SECTION 4.55(1A) MODIFICATION APPLICATION | SSD-10375 MOD 1 PITT STREET NORTH OVER STATION DEVELOPMENT

This updated section 4.55(1A) Modification Application has been prepared on behalf of Pitt Street Developer North Pty Ltd (**the Applicant**) to amend SSD-10375 which applies to the Pitt Street North Over Station Development (**PSN OSD**) Stage 2 SSD-10375 at 252 Pitt Street, Sydney.

The application seeks a number of minor modifications and materiality clarifications. These include clarification of and minor amendments to the podium and tower façades, deletion of the plant rooms previously located on level 37, widening of the podium door openings and miscellaneous drawing amendments.

Figure 4 Proposed Modification to Northern Podium Façade

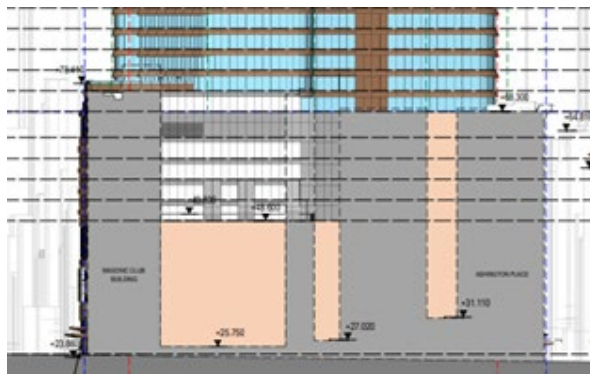
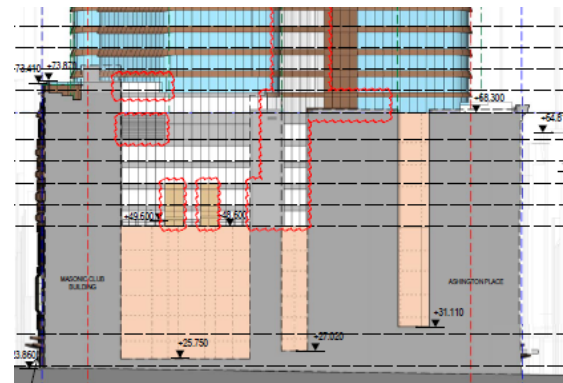
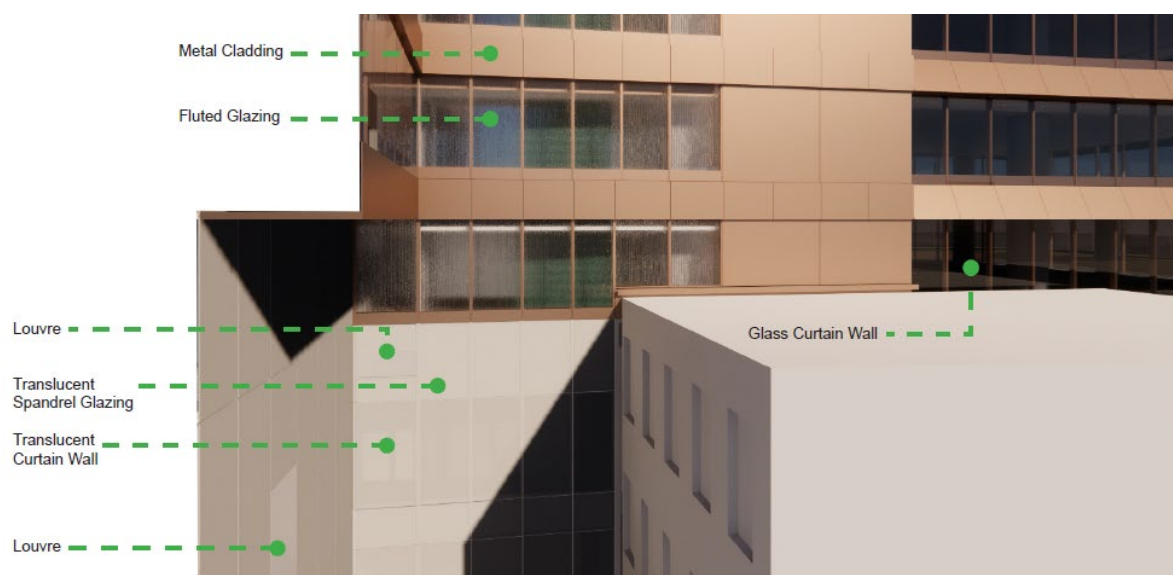
A clarification of the materials on the northern podium façade adjacent to the lightwells of the Masonic Building and Ashington Place is proposed. The white spandrel glazing on the columns has been clarified to be metal cladding and a correction has been made to the colouring on the SSD DA drawings differentiating between translucent curtain wall and white spandrel glazing.

The proposed modifications are illustrated in **Figure 4** and the computer generated image (CGI) at **Figure 5** and will result in the same visual appearance and reflective performance as those outlined in the SSD DA approval.

- an update to the level 11 terrace balustrade to a continuation of the translucent glazing below;
- a minor increase in the extent of the mechanical intake/ exhaust louvres; and
- clarification that the glazing adjacent to the amenities is fluted glazing as opposed to a glass curtain wall as noted on the SSD DA approval plans.

Figure 6 Proposed Modification to Northern Tower Façade

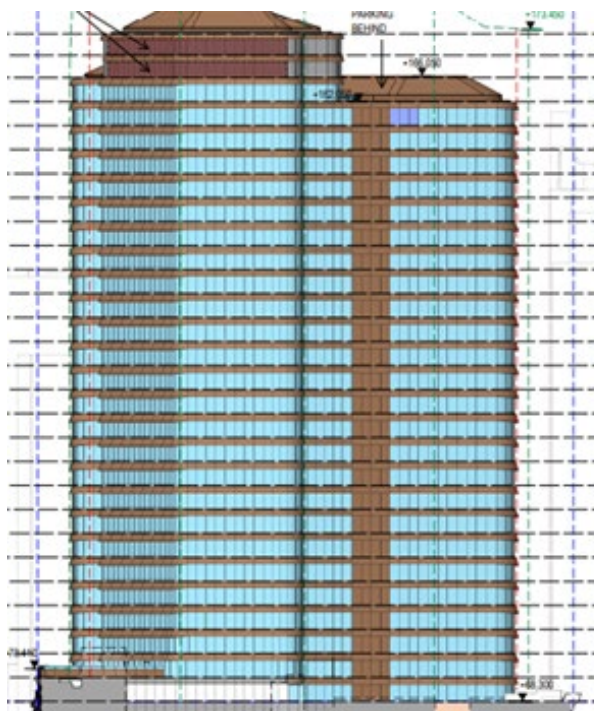
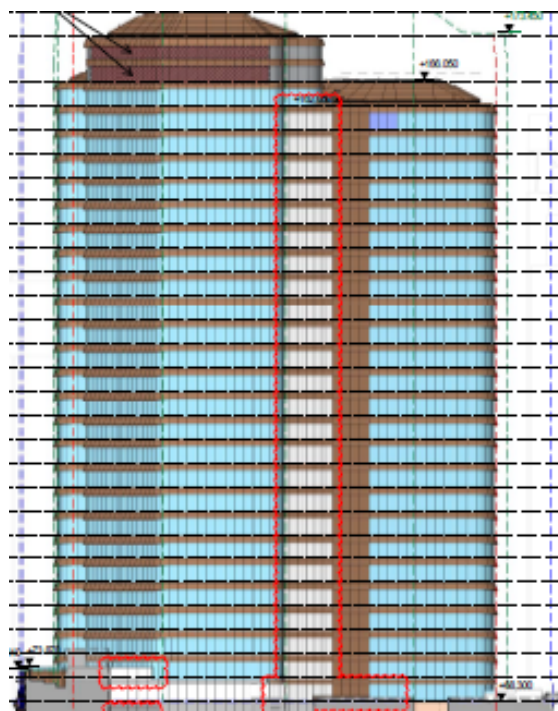
A correction has been made to the Northern Tower façade as illustrated in **Figure 6**. The approved plans show a glass curtain wall adjacent to the amenities and this has been corrected to fluted glass to provide required privacy. The materiality of this portion of the façade will have the same neutral colour and appearance as originally intended.

Figure 7 Correction to Eastern Podium Façades

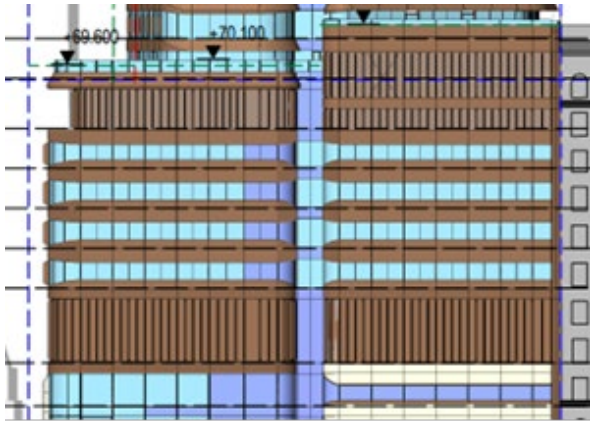
A correction has been made to the podium façade (level 5 through to level 9) on the eastern and western elevations to accurately show the corrugation detailing. This change is a graphical fix as illustrated in **Figure 7** and **Figure 8**.

Figure 9 Correction to Southern Tower Façade

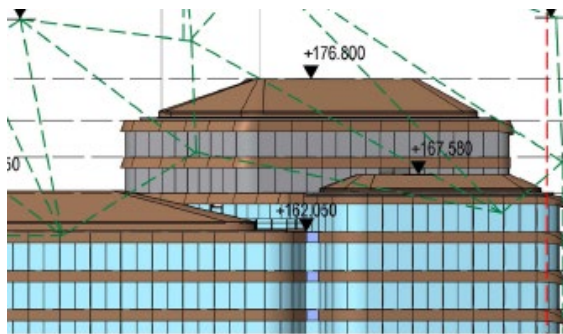
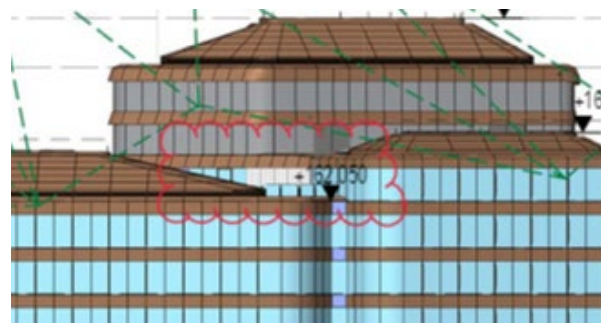
A correction has been made to the south western tower façade (level 35) to show fluted glazing adjacent to the amenities. A correction has also been made to the south western roof detailing, this change is a graphical fix as illustrated in **Figure 9**.

Figure 11 Proposed General Arrangement Elevation North Western Façade (North – South Section)

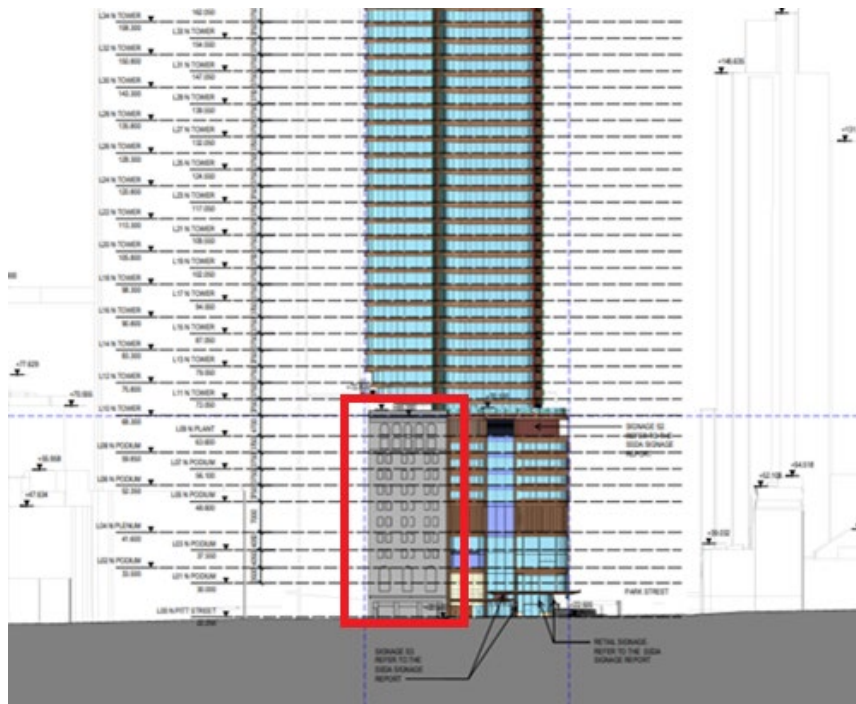
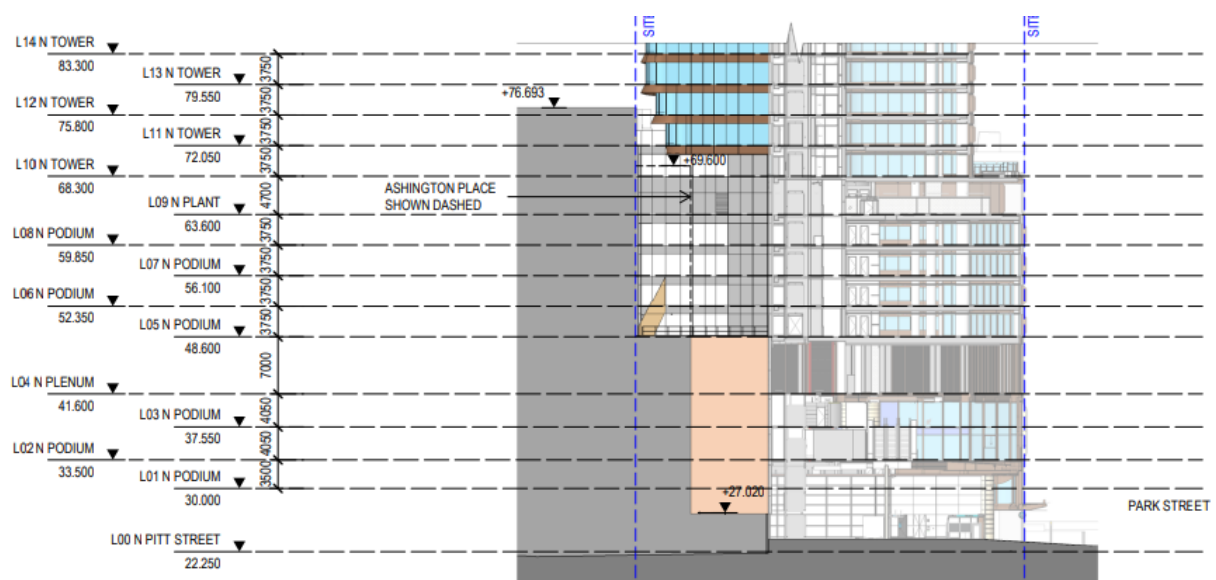
The north western façade of the OSD podium was obscured in the approved General Arrangement Elevation West Elevation - Pitt Street Plan (drawing SMCSWSPS-FOS-OSN-AT-DWG-960001) as illustrated in **Figure 10**.

As part of this modification application it is proposed to include an additional plan General Arrangement Elevation North Western Façade (North – South Section) (SMCSWSPS-COX-OSN-AT-DWG-960005) with details of the secondary western façade as illustrated in **Figure 11**.

The façade materiality consisting of a translucent curtain wall and white spandrel glazing is consistent with the design intent as per the Pitt Street North Design Guidelines and as outlined in the Architectural Design Report prepared by Foster + Partners accompanying the SSD DA submission.

Figure 12 Modification to Level 10 Terrace Openings

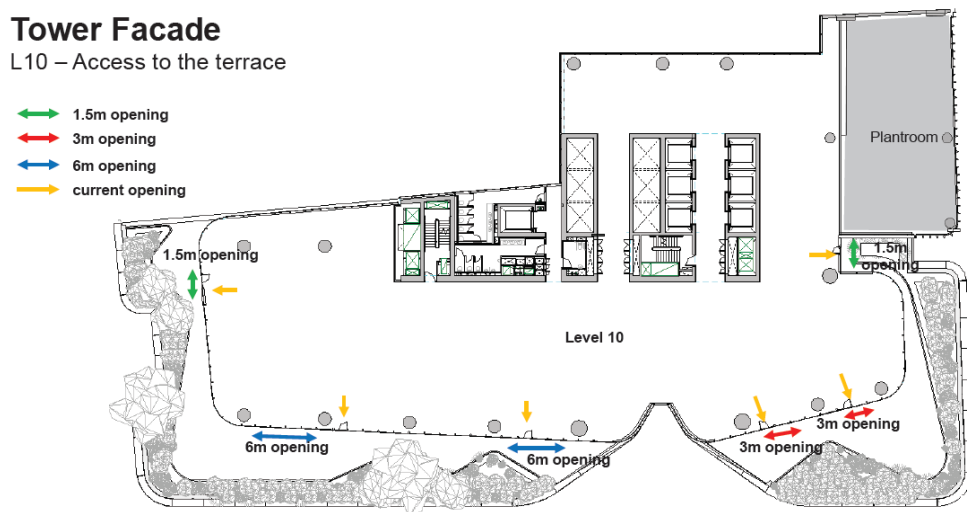
It is proposed to modify the Level 10 and Level 11 terrace door openings from single width swing doors to sliding doors of various widths as illustrated in **Figure 12** and **Figure 13**.

The modified door openings will improve the amenity of the tower including the usability of and access to the terrace areas. Both terraces have a 1.8m high glass balustrade around their perimeter to improve the usability of these spaces and the modified door openings will not be visible from the surrounding public domain.

Figure 14 Proposed Modification to Northern Podium Façade

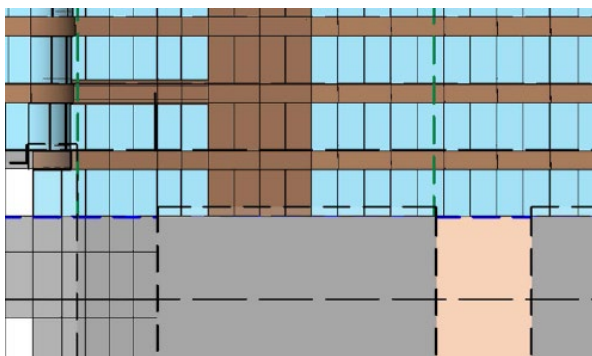
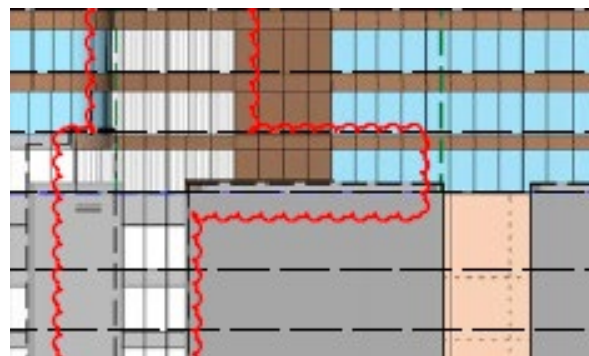
It is proposed to raise the Level 10 horizontal transom adjacent to Ashington Place to allow for adequate waterproofing structures between the two buildings. Currently the approved SSD DA plans show a full height curtain wall window in this location adjacent to the unfinished boundary wall of Ashington Place as illustrated in Picture 1 of **Figure 14**.

As illustrated Picture 2 of **Figure 14** and in **Figure 15** the modification proposes a box gutter at the height of the adjacent building structure with curtain wall window above and block wall infill under the transom.

Figure 15 Modification to Level 10 window transom

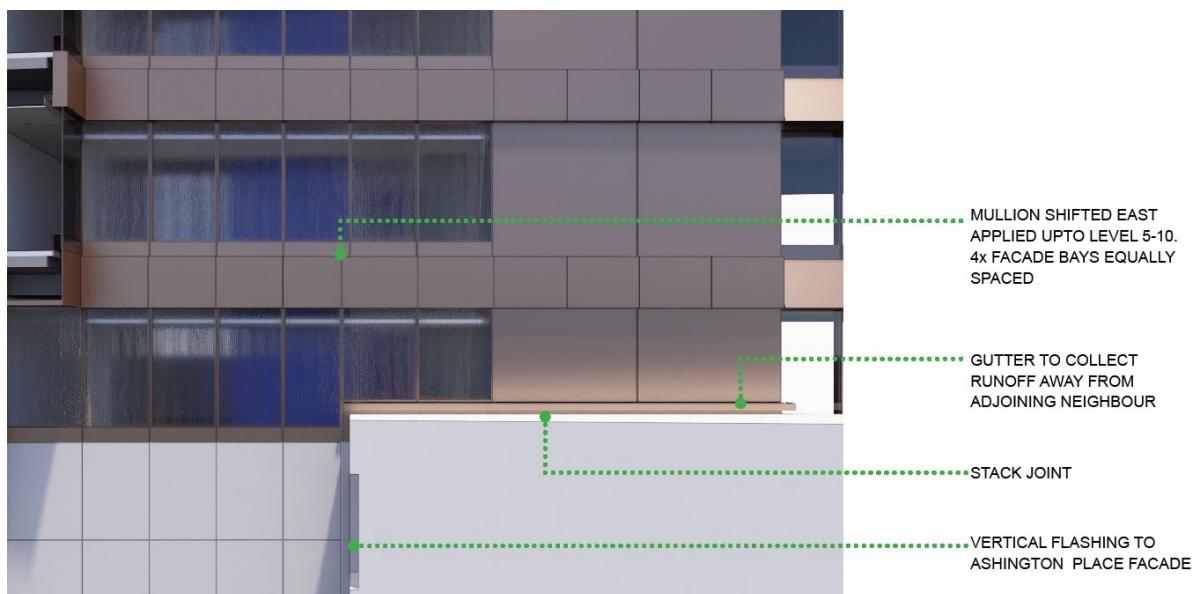
The proposed modification will not result in any fixture being secured to Ashington Place which protrudes into the PSN site. Sealant will be applied to prevent water seeping in between the PSN OSD and Ashington Place Structures.

In addition to aiding in constructability, the modification will result in an improved outlook from Level 10 of the OSD, prevent difficulties with maintaining windows in this location (cleaning etc) and will not be perceptible from the surrounding public domain.

Figure 16 Proposed Modification upper to tower levels

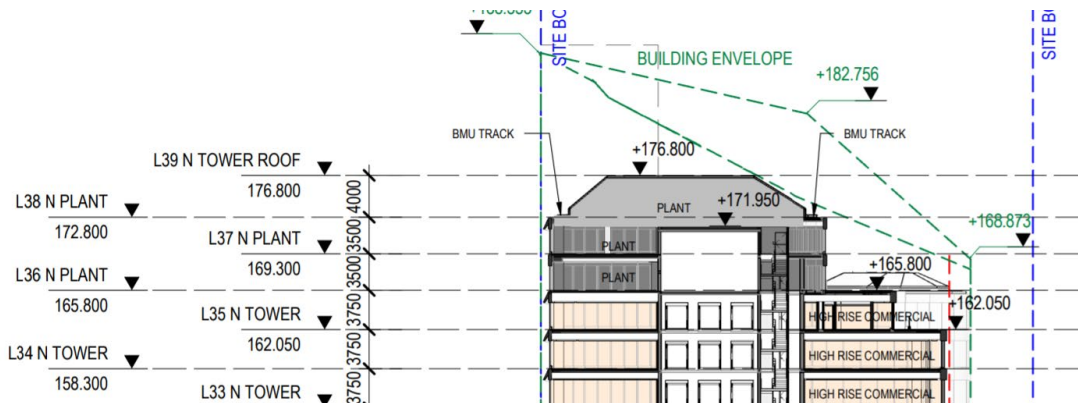
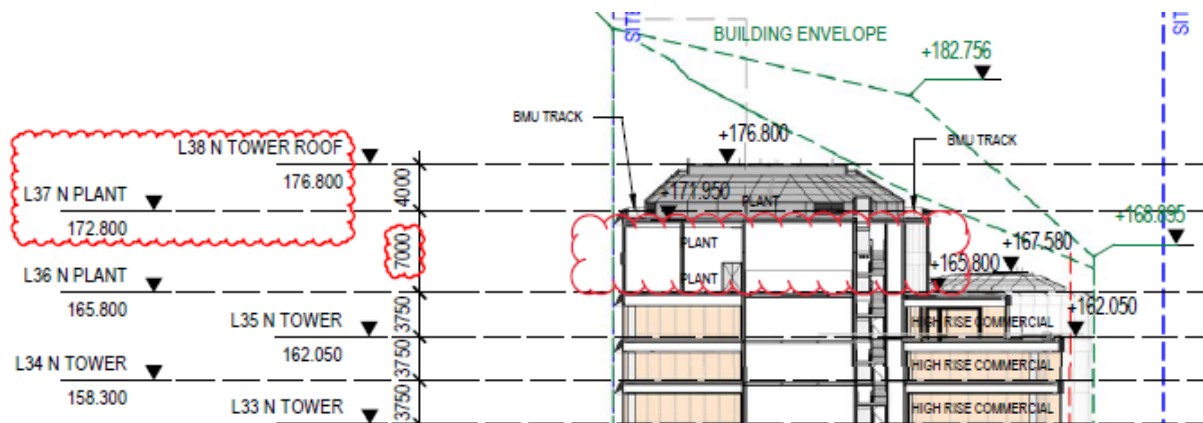
The Level 37 slab and plant rooms (detailed in SMCSWSPS-FOS-OSN-AT-DWG-933713) are proposed to be removed rendering this drawing sheet redundant. As illustrated in Section B-B in **Figure 16** this change results in a double level void but no external changes to the façade or height of the building.

As a consequence of removing the previous level 37, the upper levels of the tower and roof are renamed.
